**Flood Control Project Maintenance
Levee Inspections**
LMA District Cover Sheet
Spring 2016 Levee Inspection Results

Reclamation District No. 2064 River Junction

Levee Inspection Report By Mile - Spring 2016

Photo 2 of 2 : UCIP_SP_2016_19063_31860.jpg

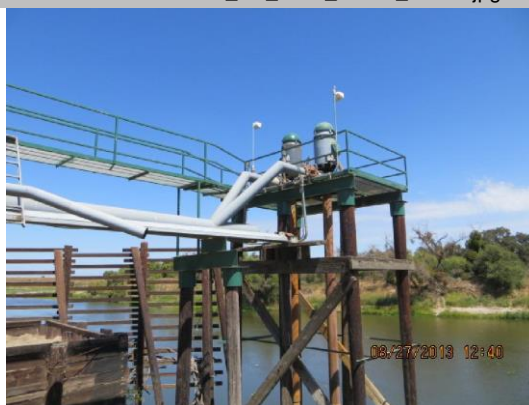
LM Start	4.72	Rating **	M	Issue No.	34
LM End	4.72	Issue Type +	En	Location *	LS
Category	Supplemental			GPS Latitude/Longitude	
				Start	End
Item	DWR UCIP Field Study			37.670161 °	37.670161 °
				-121.246973 °	-121.246973 °
DWR ID					
Comment Code					
Inspector Comment					
FS_ID:19063 DS_ID:20520 EP_NO: 3359 Repair Type: Non-Urgent Crossing Status: Indicator Found UCIP Comments: Pipe not found. Need to determine disposition of pipe as all other appurtances remain. FIELD_STRUCT_DESC: 1 of 2: 24-inch pipe through the levee 3.5 feet below the crown (Permit No. 3359, 1961). Pump mounted on pipe structure in the river; protective fender in the stream, wooden walkway to the pump structure. Siphon breaker on the landward side. Originally included in the 1968 O&M manual. FS Date: 8/27/2013

Pump platform, walkway, and fender remain in stream. No 24-inch pipe found.

Photo 2 of 2 : UCIP_SP_2016_19064_31862.jpg

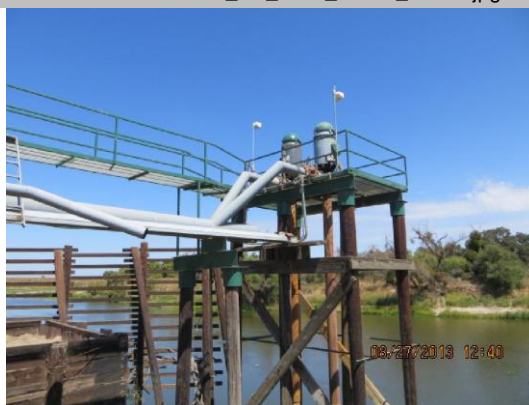
LM Start	4.72	Rating **	M	Issue No.	35
LM End	4.72	Issue Type +	En	Location *	LS
Category	Supplemental			GPS Latitude/Longitude	
				Start	End
Item	DWR UCIP Field Study			37.670161 °	37.670161 °
				-121.246973 °	-121.246973 °
DWR ID					
Comment Code					
Inspector Comment					
FS_ID:19064 DS_ID:20530 EP_NO: 3359 Repair Type: Non-Urgent Crossing Status: Indicator Found UCIP Comments: Pipe not found. Need to determine disposition of pipe as all other appurtances remain. FIELD_STRUCT_DESC: 2 of 2: 18-inch pipe through levee 3.5 feet below the crown (Permit No. 3359, 1961). Pump mounted on pipe structure in the river; protective fender in the stream, wooden walkway to the pump structure. Siphon breaker on the landward side. Originally included in the 1968 O&M manual. FS Date: 8/27/2013

Pump platform and fender visible on WS toe.
